June 25, 2020

Re: Tier 2 Pathway Application: Application No. B0059; California Bioenergy LLC and ABEC Bidart-Old River Dairy

(photo below shows large and small ponds near the covered lagoons)

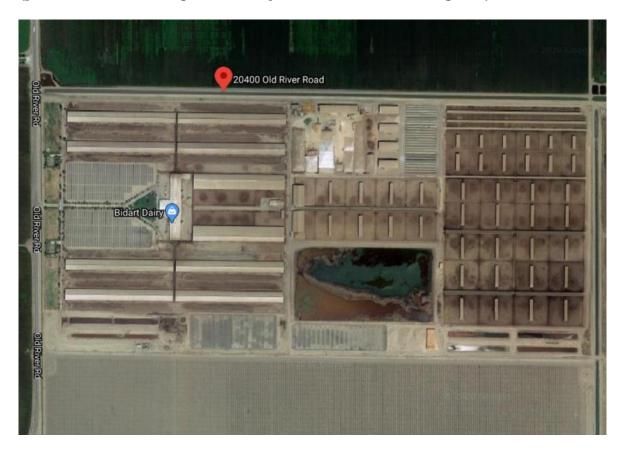
The handling of the digestate is not addressed. It may be assumed the digestate goes into an effluent pond and is eventually used for irrigation of crops but without access to the pertinent information, which is redacted, it is impossible to know for sure. Besides the covered lagoons there are several large and small ponds located at this dairy. The emissions from any digestate ponds and any other liquified manure ponds must be fully revealed in order to accurately assess the health impacts of this pathway. This includes all ammonia emissions, methane emissions, and nitrous oxide emissions (N2O). Any GHG emissions from these ponds must be calculated and applied to increase the carbon intensity calculations. Without these emissions being factored in, the carbon intensity is inaccurate and this pathway cannot be approved.
